CERTIFICATE OF THE SECRETARY OF ENERGY AND ENVIRONMENTAL AFFAIRS
ON THE
EXPANDED ENVIRONMENTAL NOTIFICATION FORM

PROJECT NAME : CambridgeSide 2.0
PROJECT MUNICIPALITY : Cambridge
PROJECT WATERSHED : Charles River
EEA NUMBER : 16176
PROJECT PROPONENT : New England Development
DATE NOTICED IN MONITOR : March 25, 2020

Pathway to 26% Mitigation Level – Whole Project

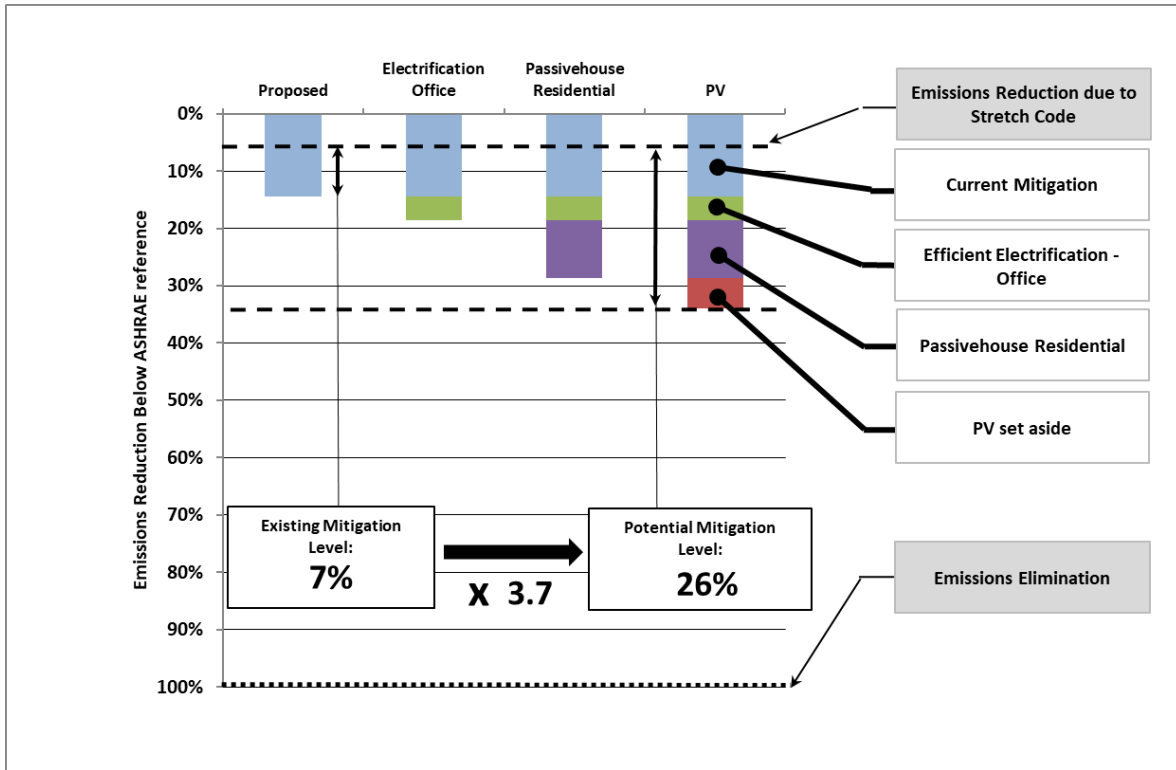
To correct the currently-proposed Mitigation Level, we have estimated “mitigated” energy use¹. Using this estimate, the project (all buildings) is currently-proposed to have a Mitigation Level² of 7%. This can be improved by about x3.7 to 26%. In summary:

Pathway to 39% Mitigation Level – Residential Buildings

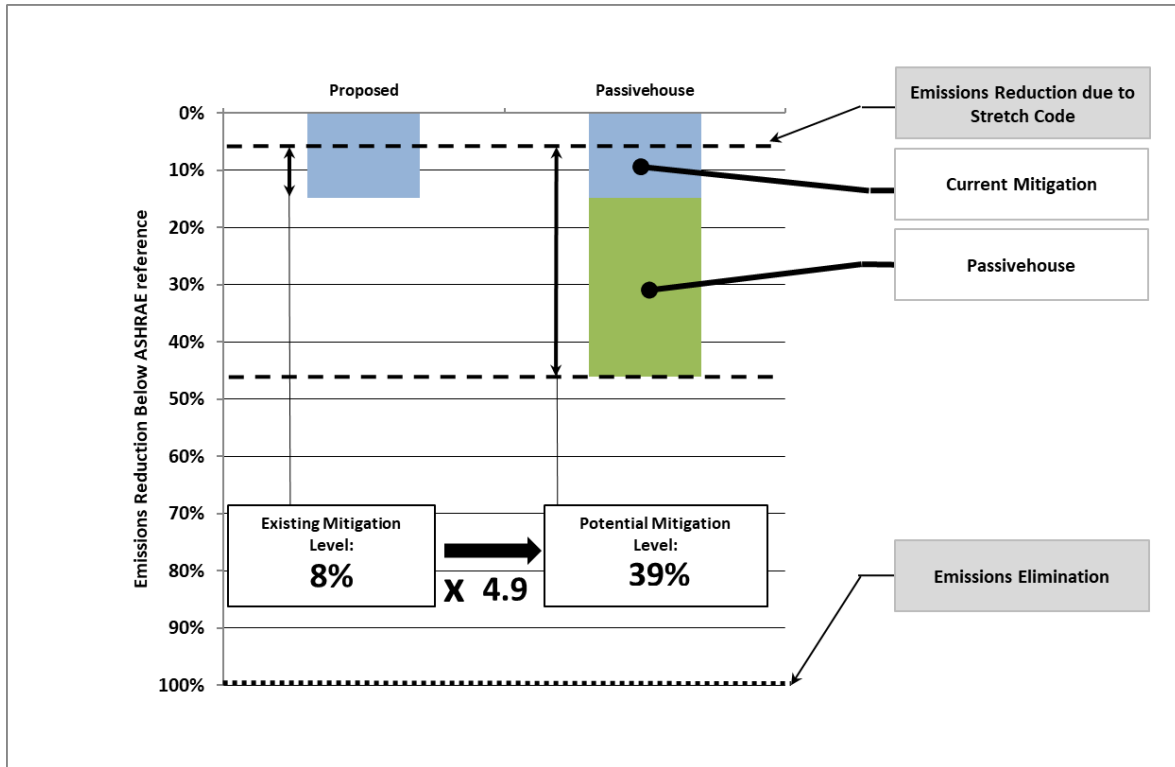
Using the same estimates to correct “mitigated” scenario, just the residential portion of the project would have a Mitigation Level of 8%. This can be improved by about almost x5 to 39%. In summary:

- The currently-committed efficiency strategies deliver a Mitigation Level (ML) of 8%. This is accomplished with improved windows, roof, and efficient electrification.
- Mitigation Level can be improved to 39% by building to Passivehouse standards.

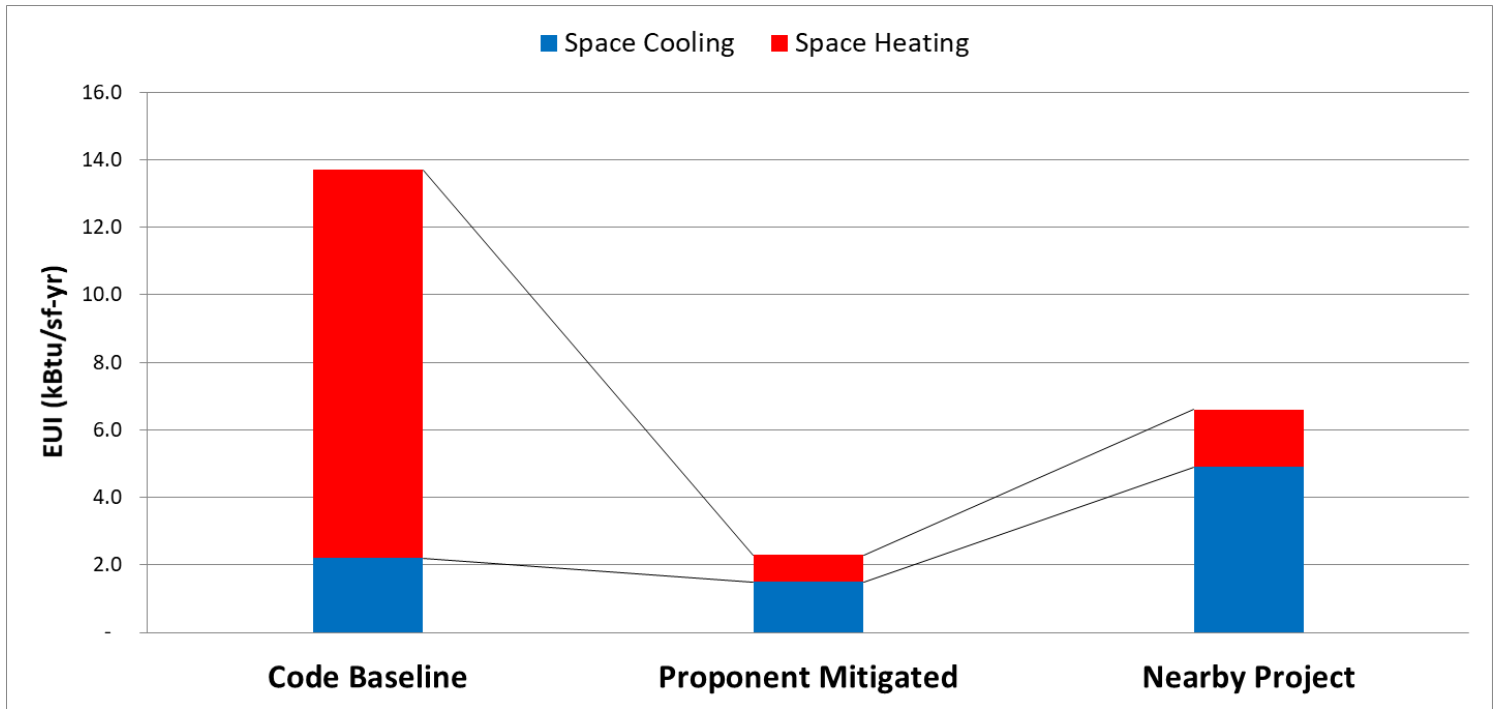
Focusing, on the residential buildings’ heating end use, the model shows a **93% reduction in heating end use consumption**. In fact, heating consumption for the “mitigated” scenario is even lower than expected Passivehouse level performance. For cooling end use, both “Code Baseline” and “Mitigated” appear unlow.

The illustration on the next page shows heating and cooling end use for: code-performance energy consumption (left), the modeled “mitigated” performance (middle), and the results from a similar, nearby residential apartment project³ (right). As shown, both heating and cooling end use consumption is substantially smaller than the nearby project which has substantially more envelope and other commitments.

Building Envelope and Perimeter Heating – Office/lab

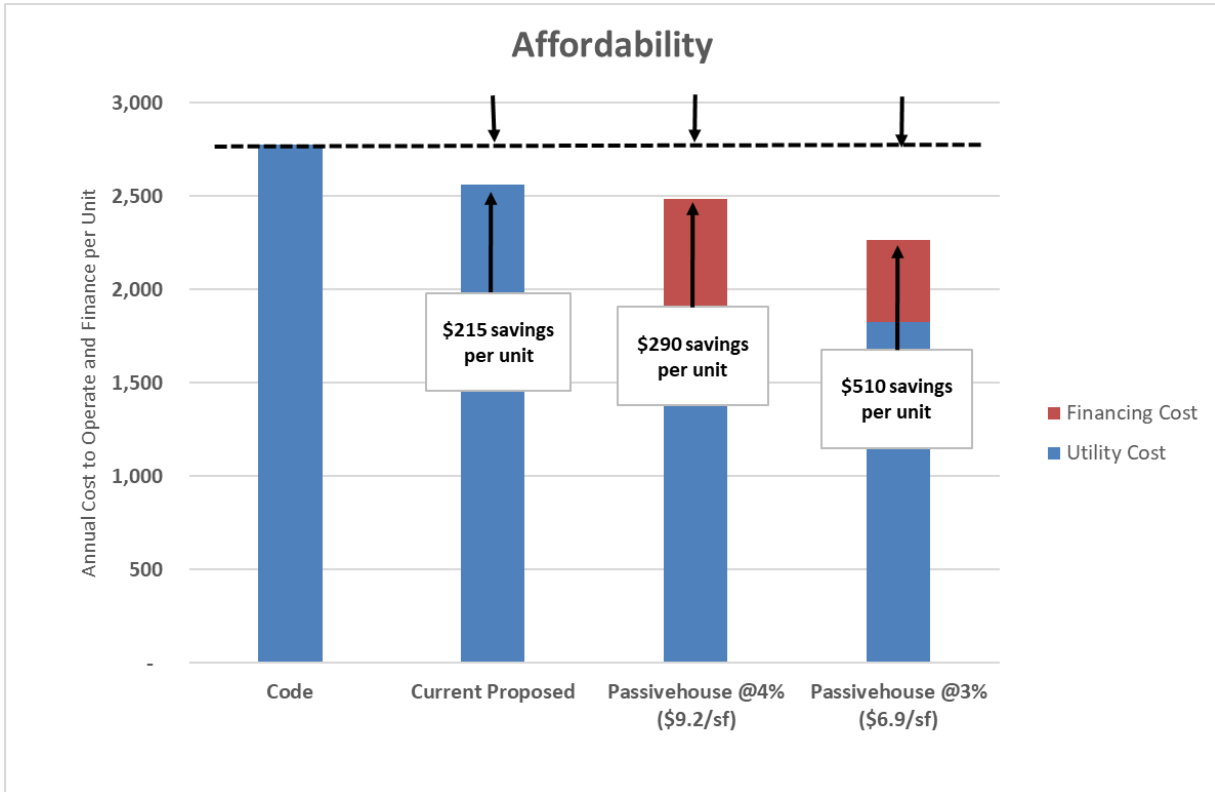
The office/lab has code level wall performance (0.055) albeit with improved windows. We recommend the proponent also examine whether further wall and/or window improvements could potentially eliminate or reduce the need for perimeter heating for this building.

Elimination/reduction of perimeter heating could potentially result in significant construction cost savings, improved comfort, and reduced maintenance. Also, elimination/reduction of perimeter heating may also make full electrification more feasible and thus improve GHG reduction.
